Cadillac

SERVICEMAN

DECEMBER, 1957

Fig. 1

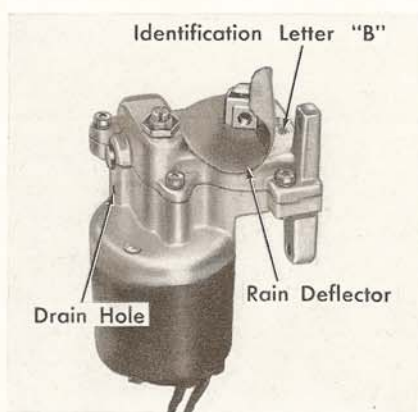
IMPROVED TYPE POWER VENTILATOR WINDOW REGULATOR

An improved type electric ventilator window regulator assembly has been developed to resist entry of rain water through the gear box, and is incorporated in 1958 cars equipped with this option, after Engine Number 009858. The improved type, now available from the factory Parts Warehouse, should be installed on all cars equipped with the original type during the owner's next routine service visit.

The late type ventilator regulator assembly incorporates design improvements to prevent this condition, including: rain deflector washer; waterproof, non-corrosive grease in the gear box; an overlap at the split line of the motor shell; undercoating material over the entire motor assembly; and drain holes on lower sides of gear box and motor.

Identification of early and late assemblies must be made by inspection of the code letter adjacent to the date code, as shown in Fig. 1. Code letter "B" designates the late type, as compared to the letter "A" on the early type. Part Numbers remain 4719528 right, and 4719529 left, as originally released.

Fig. 2

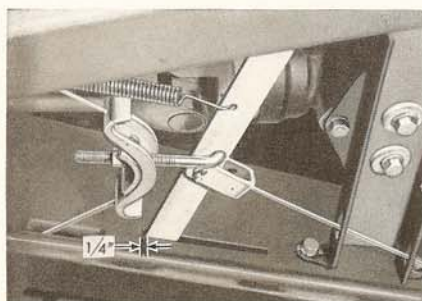
The majority of these cases can be corrected by performing the Parking Brake Adjustment as described in Section 8, Note 4 of the 1958 Cadillac Shop Manual Supplement. When adjusting the distance from the rear relay lever to the end of the slot in

the frame side member, add an additional $\frac{1}{8}$ ", making the total distance $\frac{1}{4}$ " as shown in Fig. 2 rather than $\frac{1}{8}$ " as specified in the Shop Manual.

If, after the above adjustment is made, the parking brake does not return to the fully released position, check the intermediate cable from the bell crank to the relay lever for interference at either the No. 2 body hanger, Fig. 3, or the point where this cable enters the frame from within the No. 2 body hanger. If a slight amount of interference is noted at these points, the intermediate cable may be reversed, end for end, attaching the large, trunnion end of the cable to the relay lever, and allowing the smaller end of the cable to pass through the No. 2 body hanger and frame. If adequate clearance cannot be obtained by reversing the cable, it will be necessary to remove the interference, using a file or a draft punch and hammer. The area in which interference usually occurs is indicated by the dotted line in Fig. 3.

Fig. 6

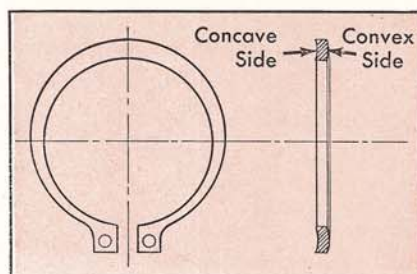
Extreme care should be used when installing any snap ring of the Truarc type used in the Hydra-Matic transmission. These snap rings are convex on one side and concave on the other, as shown in the cross section illustration,

Fig. 6, and must be installed properly to assure maximum holding force.

Fig. 7

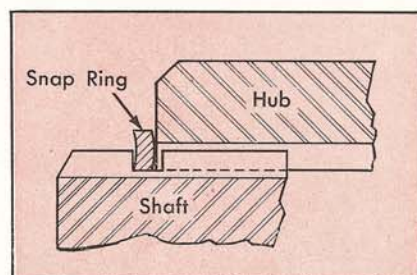
The snap rings should be installed with the convex, or rounded side, contacting the hub of the part being retained, as shown in Fig. 7, so that

the sharp edge will engage the opposite shoulder of the snap ring groove. Always use a new snap ring on reassembly, and avoid expanding either type ring any further than necessary during installation.

Fig. 8

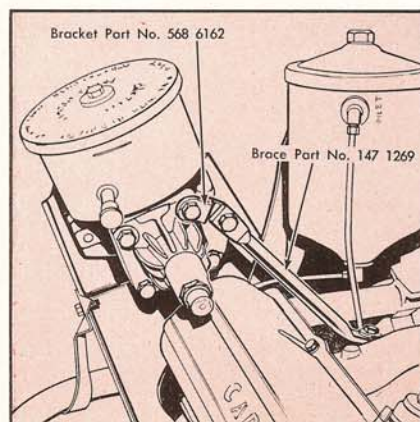
AN extremely noticeable vibration similar to a "growl" has been reported at about 1000 RPM on some early production 1958 series cars. This vibration is prevented on later

production cars by a power steering pump rear brace, Part Number 1471269, with attaching bracket, Part Number 5686162, as shown in Fig. 8. However, this brace did not reach production until Engine Number 003214 on cars equipped with coil springs. A similar brace and bracket has been installed on all Air Suspension cars since the beginning of production.

An installation kit, Part Number 3631146, has been shipped by the factory as a shortage item for all coil spring cars prior to Engine Number 003214. This kit contains the brace, bracket, bolts, nut and washer necessary to install the needed brace.
